Description of proposal:	
20m x 10m shed (including office and lunchroom), bitumen apr	on.
(attach additional sheets if necessary)	
Site address: Anstey St, Longford	
CT no: NA - no title docs	
Estimated cost of project \$40,000	(include cost of landscaping, parks etc for commercial/industrial uses)
Are there any existing buildings on this property? Yes / No f yes – main building is used as Racecourse facilities.	
f variation to Planning Scheme provisions requested, justification	on to be provided:
Refer letter.	
attach additional sheets if necessary)	
No.	
s any signage required? No

RE: PROPOSED 20M x 10M SHED.

LODGEMENT OF PLANNING APPLICATION WOOLCOTT SURVEYS OBO TASRACING PTY LTD 20M X 10M SHED (INCLUDING OFFICE AND LUNCHROOM) & BITUMEN APRON ANSTEY ST, LONGFORD (PID 2853277)

Description of proposal:		
16 Unit Development (1	Existing, 15 Propose	ed)
(attach additional sheets if necessary)		
If applying for a subdivision which	n creates a new road inlea	ase supply three proposed names for
the road, in order of preference:	refeates a new road, pres	ase supply times proposed numes to
1 2.		3
21 Dww.ma.ma.a.m.d	Crossent Douth	
Site address:	Crescent, Pertin	
CT no: .62886/.14

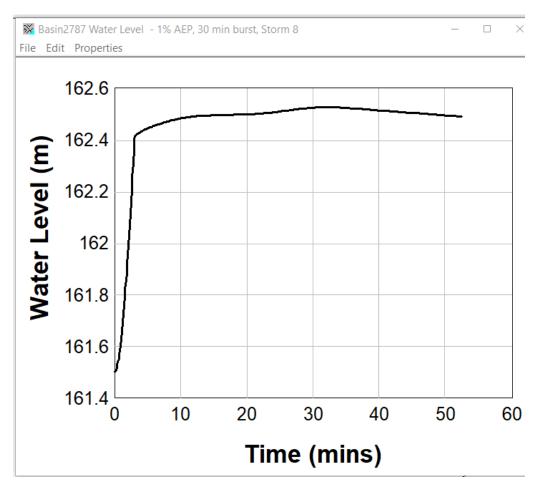
First dot point - see sheet CO4

Changing to a type 3 gave 20% AEP flow of 0l/s predevelopment with usual depression storage arrangements. Deletion of depression storage gave a predevelopment flow of 31l/s - I have used this.

With these changes Orifice size is reduced from 147mm dia to 130mm

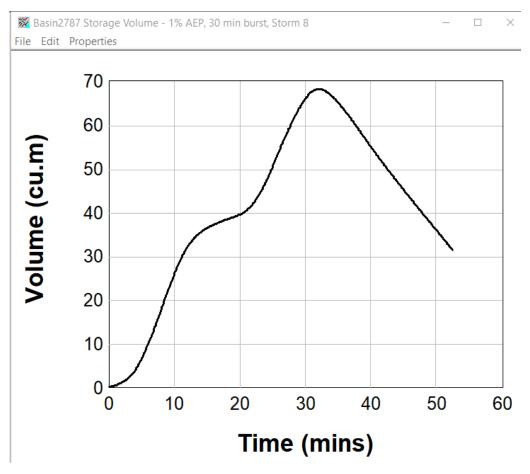
Third dot point

This review has prompted raising of the pit and pavement levels by 200 mm.

Crests are created with grades of 1 in 100 at each side. This will not be unsightly or an issue.

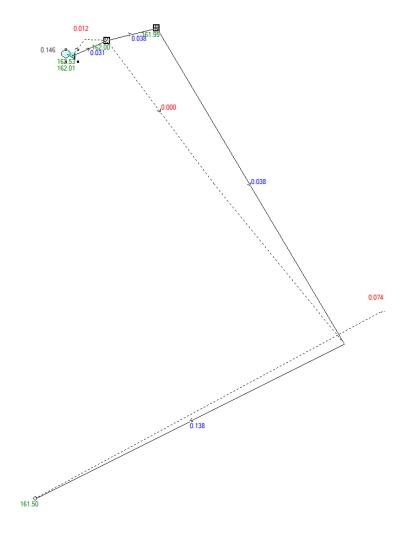
Final Dot Point

Water level set at 700mm above the pipe outlet invert (160.76 invert to 161.5 water level) in drains for the 100 year event shows the following result.

This caused a reduction in the pipe flow and a slight increase in overflow.
